Chelan Falls Powerhouse Park – Bank Stabilization

District Bid 18-01_Final Acceptance Resolution

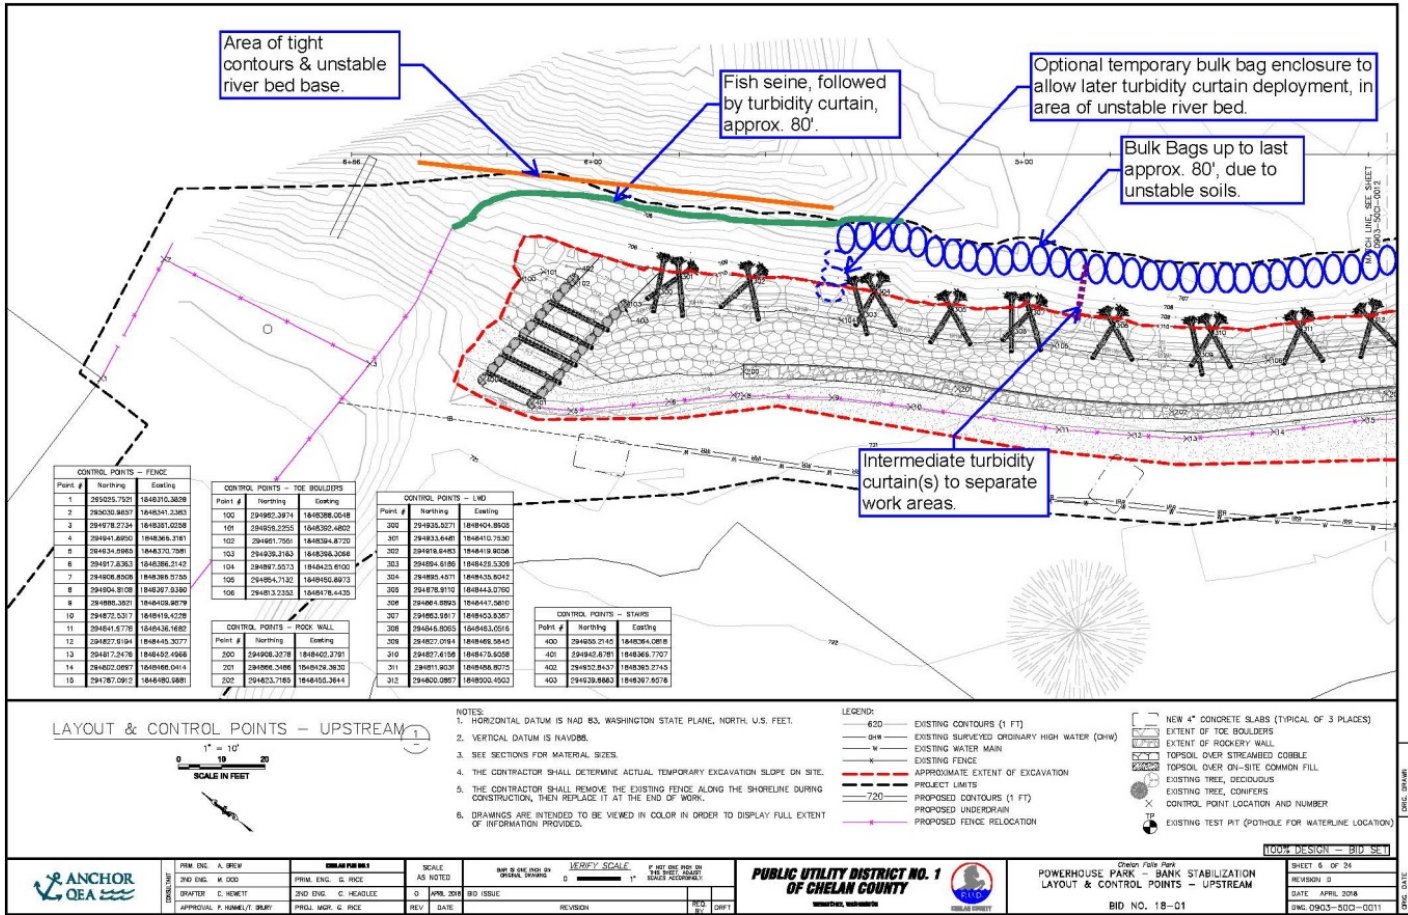
Upstream water isolation & turbidity control proposed modification, due to unstable riverbed base at steep slope area. _GR 8/20/18
